FORMER CENTRAL RETAIL PARK
ROCHDALE
DESIGN & ACCESS STATEMENT
ADDENDUM

ORRD-LRW-XX-XX-PP-A-00624_P03 | JULY 2024

This Design and Access Statement Addendum has been prepared by Leach Rhodes Walker for Wilmott Dixon and Rochdale Development Agency in support of the non material amendment to the currently consented residential development in Rochdale approval reference:22/01119/FUL.

2 Bed House Ground Floor Plan

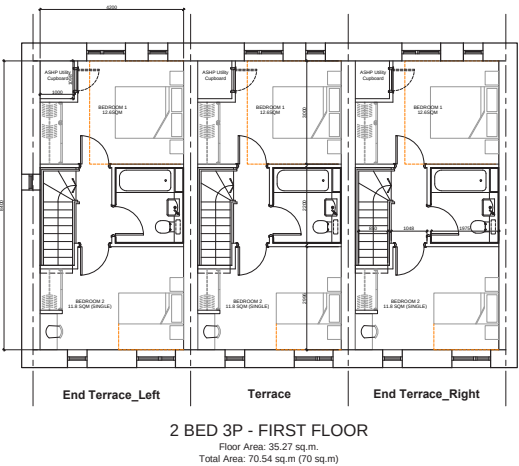
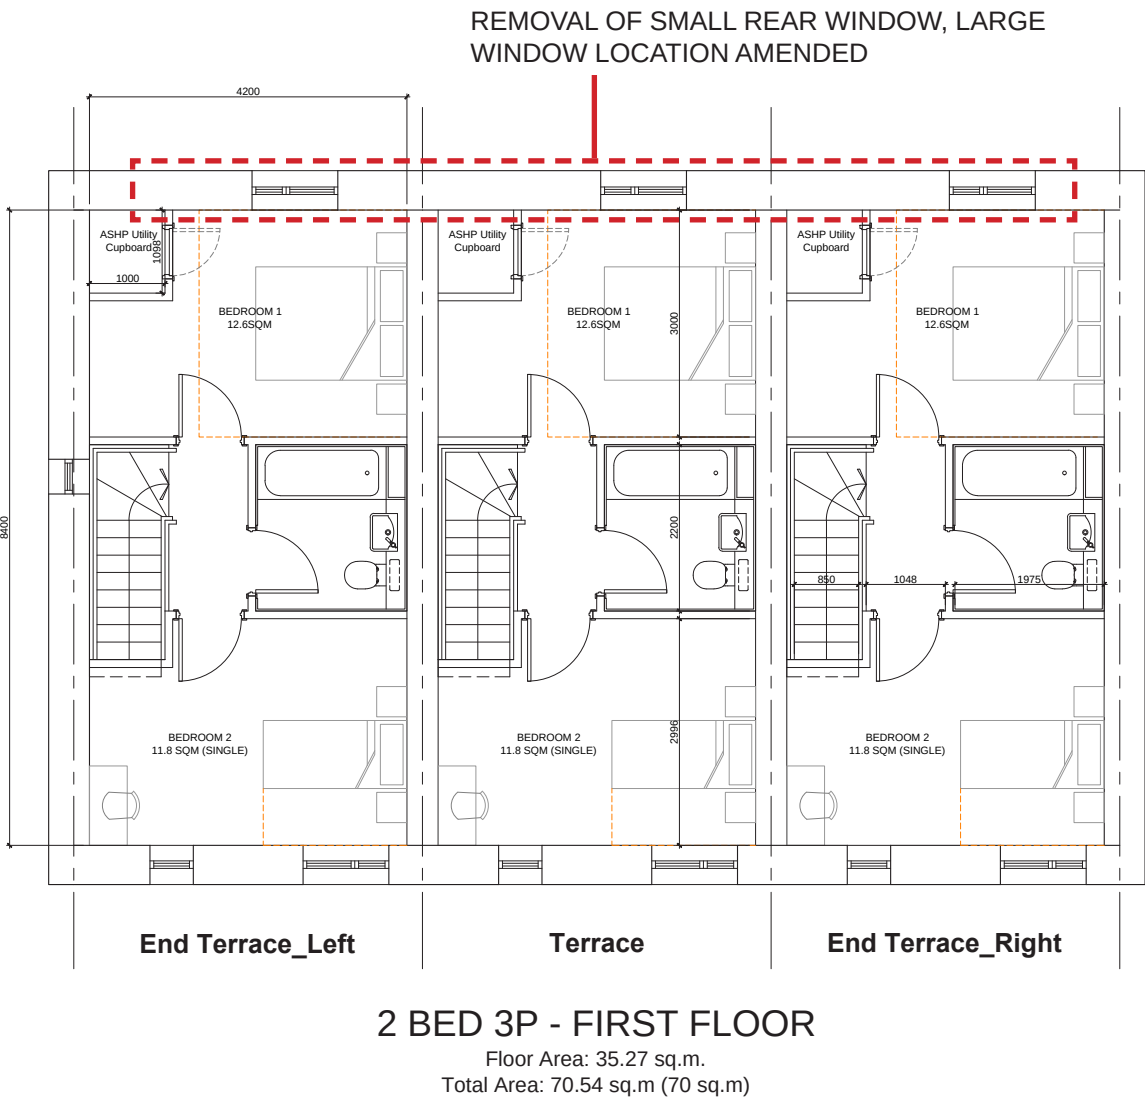
In the 2 bed house ground floor there are small amendments to the internal layout. This includes the backdoor which has been handed to open inwards. The kitchen has been adjusted from a corner layout to a straight run and the living room layout has been handed to show the seating area along the exterior wall.

2 Bed House First Floor Plan

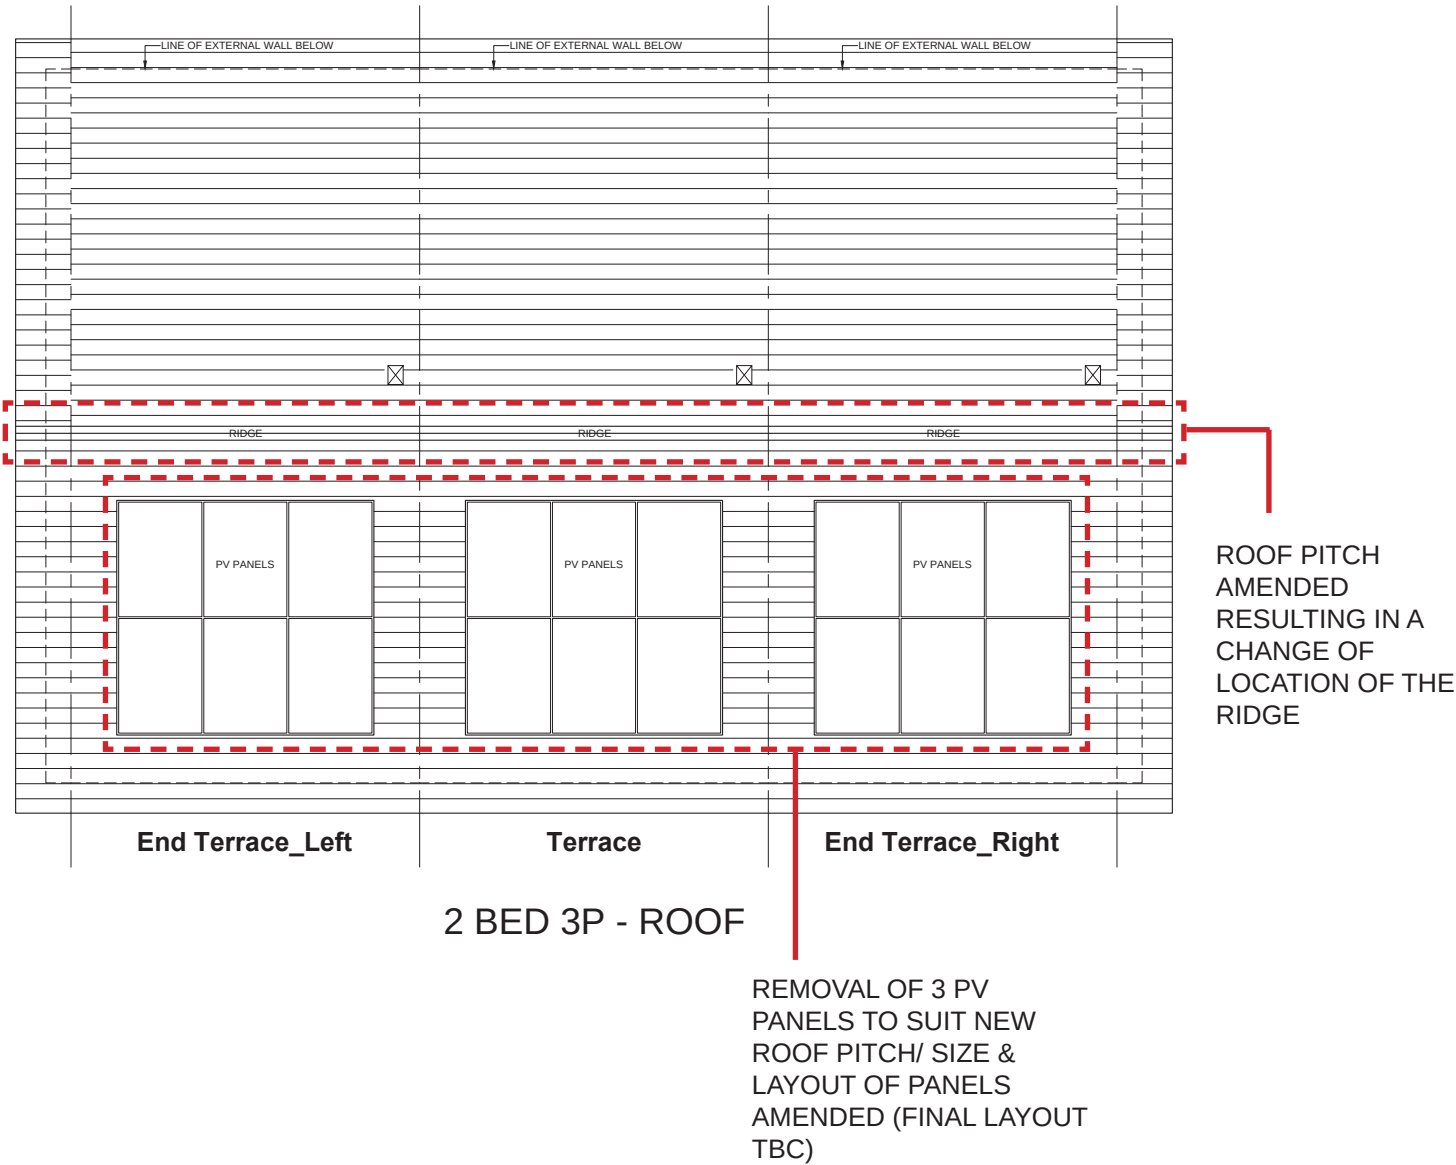
On the first floor of the 2 bed house the smaller of the two rear windows has been removed and as a result of this the larger window location has been amended to sit more centrally in the bedroom.

2 Bed House Roof Plan

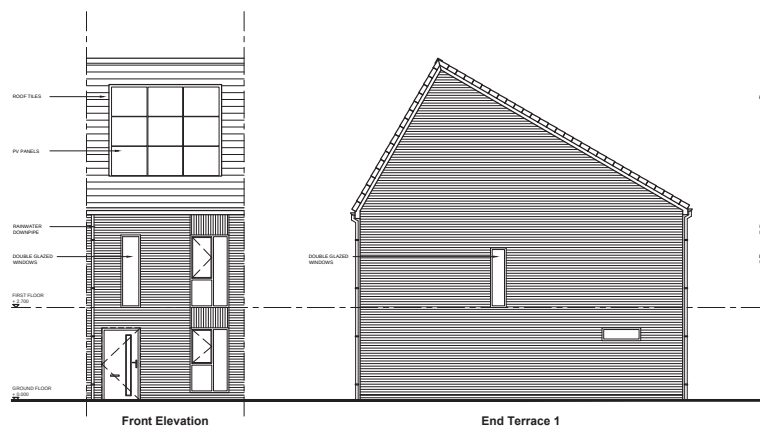
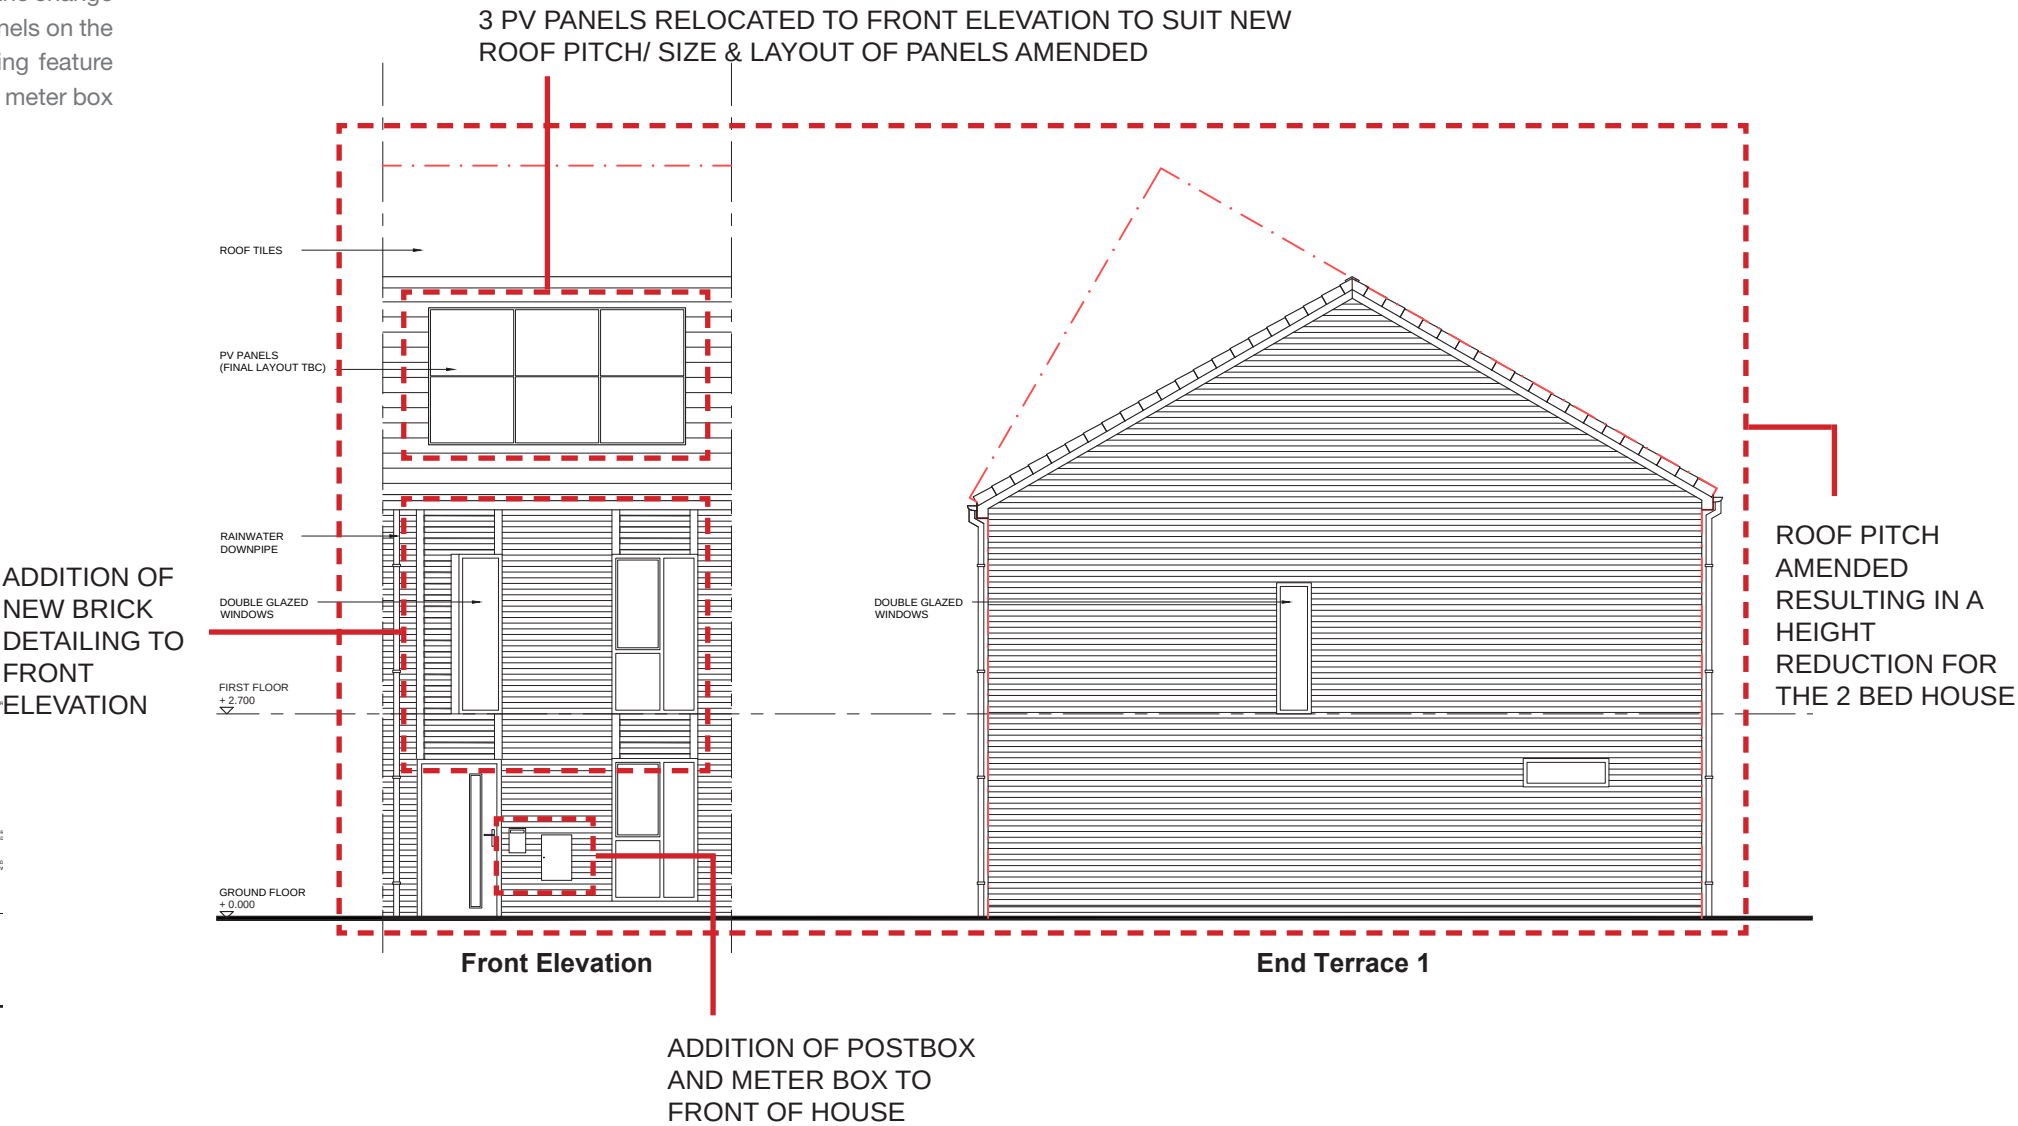
The roof plan of the 2 Bed house has been affected by the change of roof pitch resulting in the amendment of the ridge location and the reduction of 3 PV panels. The PV panels have also been adjusted in terms of size and location to suit the new roof pitch.

2 Bed House Front and Side Elevation

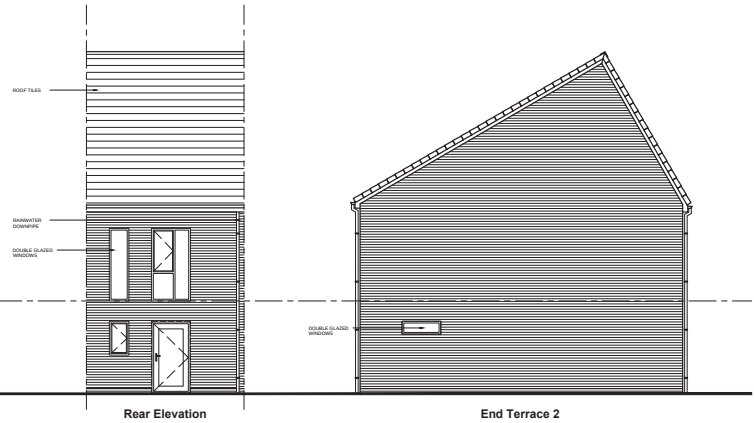
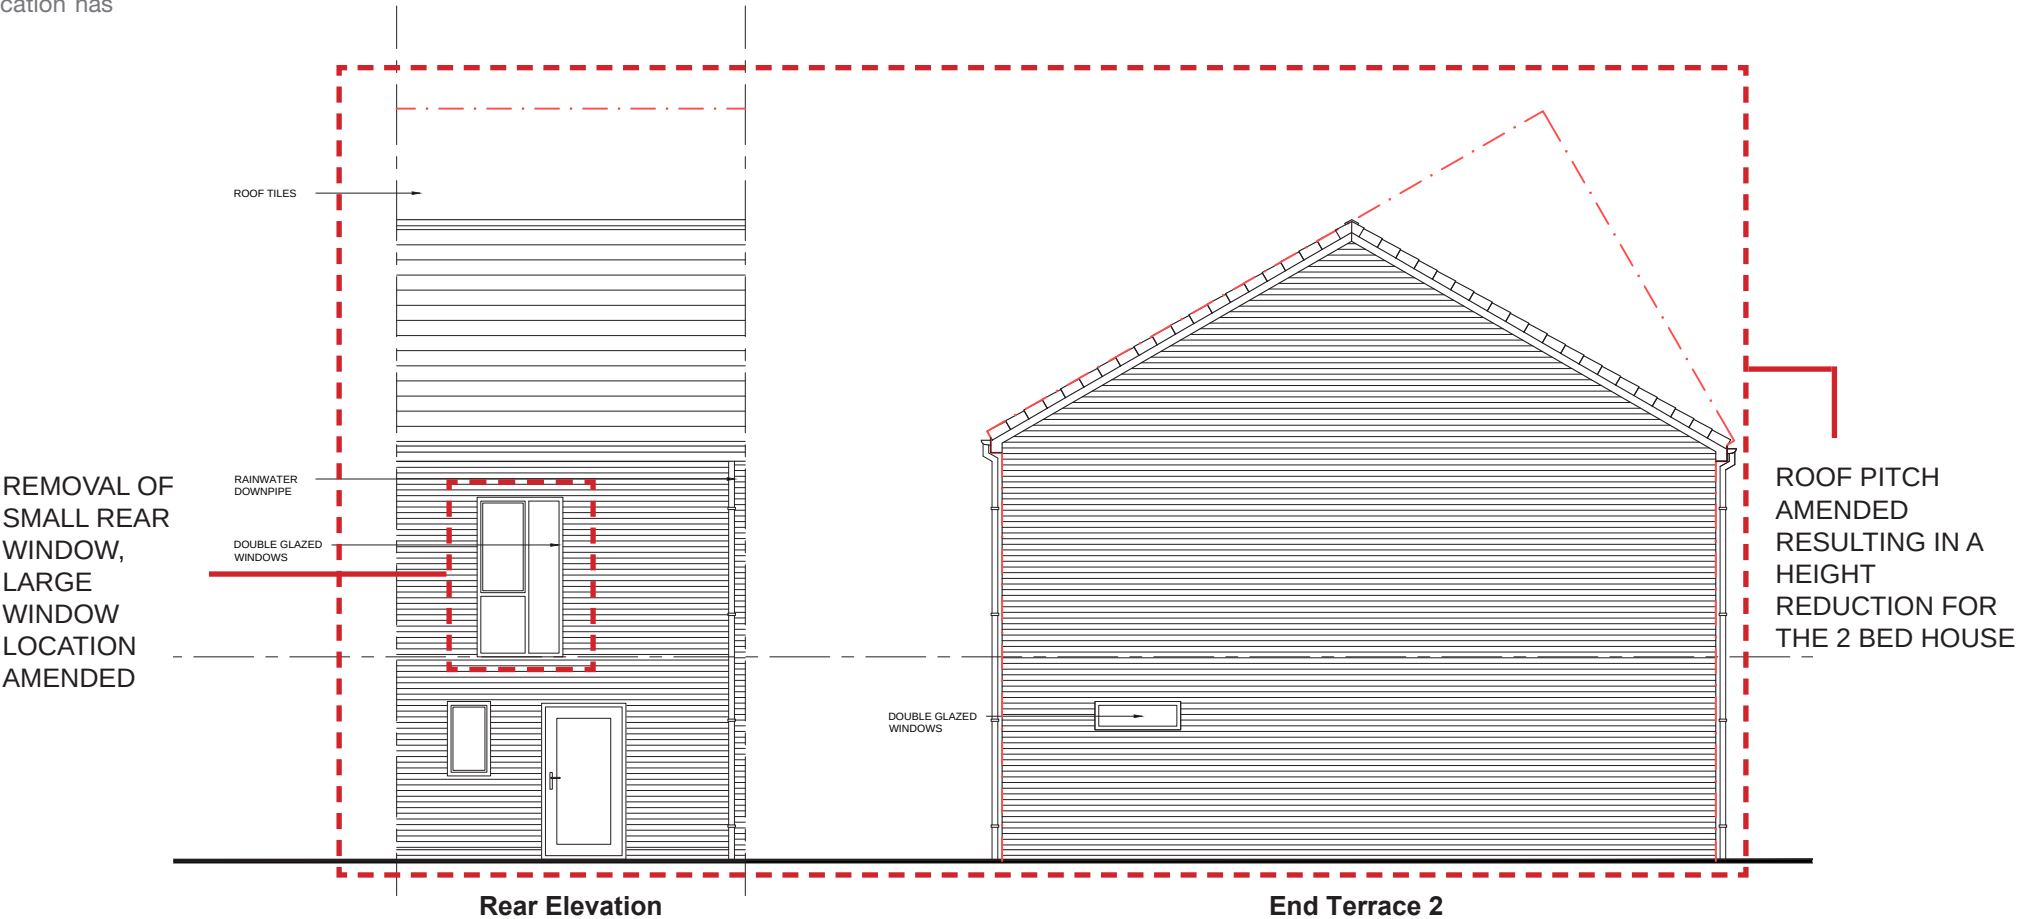
The 2 bed house front and side elevation have reduced in height due to the change in roof pitch. This has impacted the amount, size and location of PV panels on the roof. New brick detailing has been added to the front facade including feature brickwork with a 10mm recess every other course. Also, a postbox and meter box has been added to the front elevation.

3 Bed House Ground Floor Plan

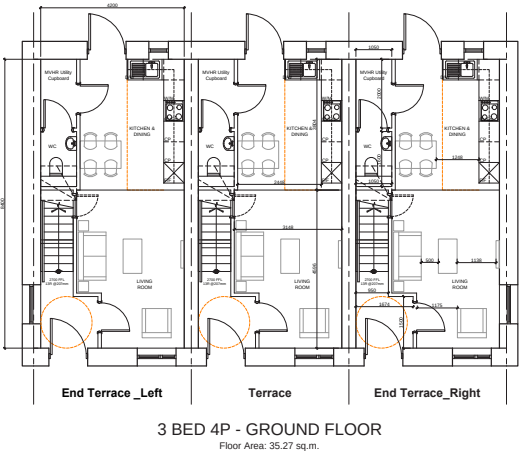
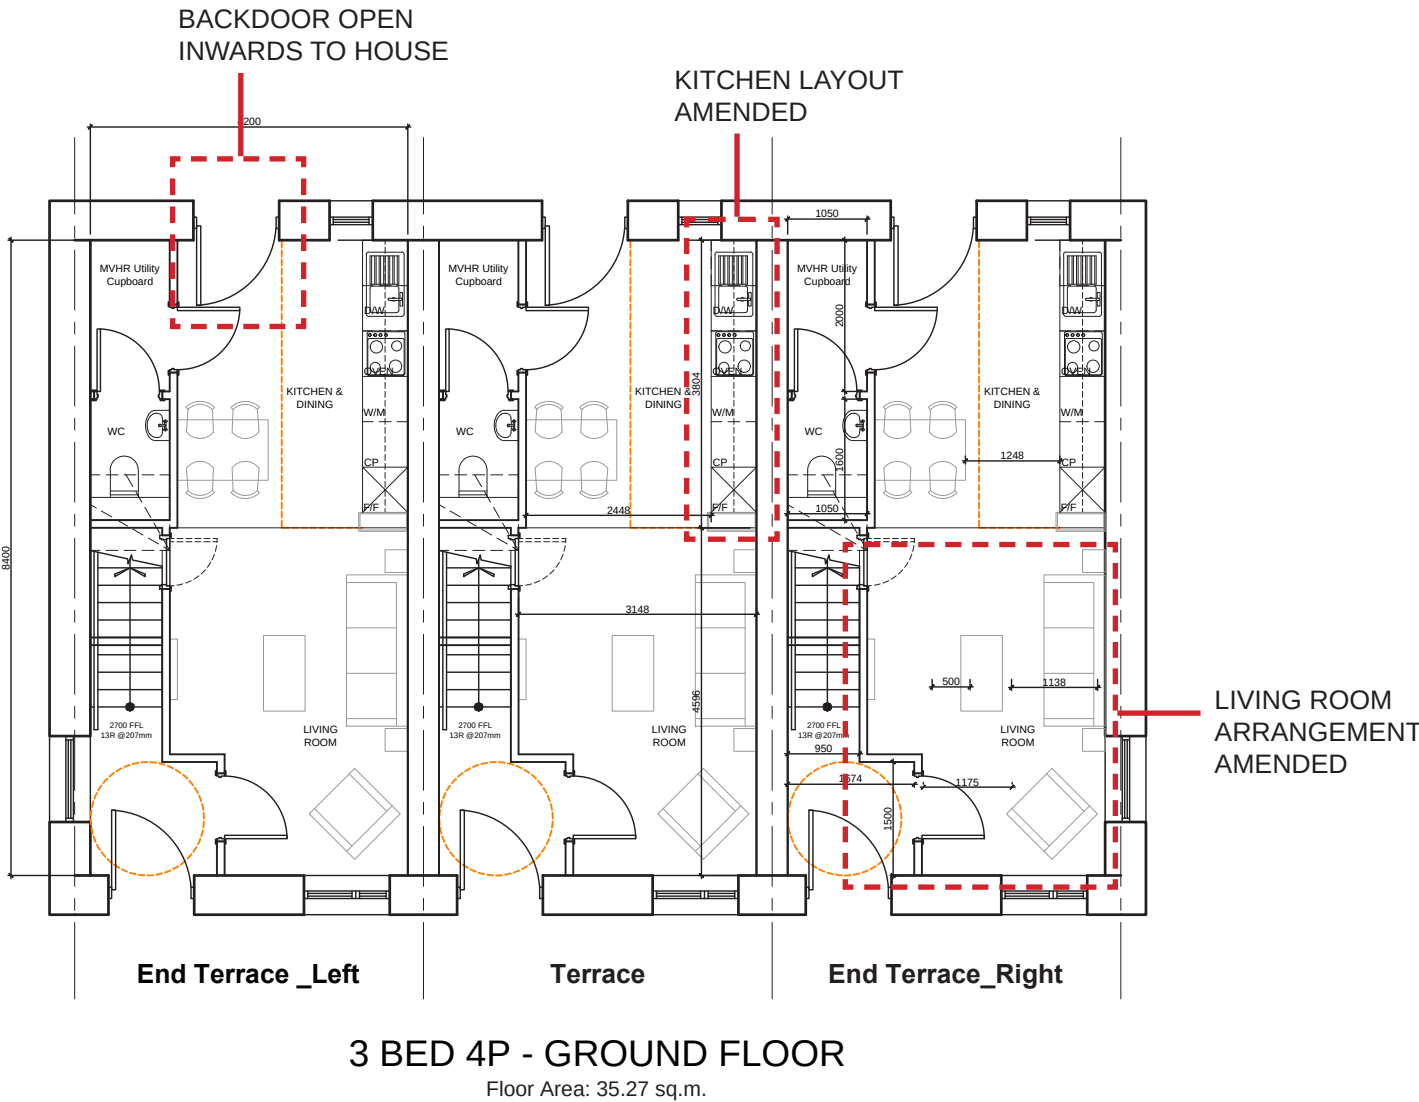
In the 3 bed house ground floor there are small amendments to the internal layout. This includes the backdoor which has been handed to open inwards. The kitchen has been adjusted from a corner layout to a straight run and the living room layout has been handed to show the seating area along the exterior wall.
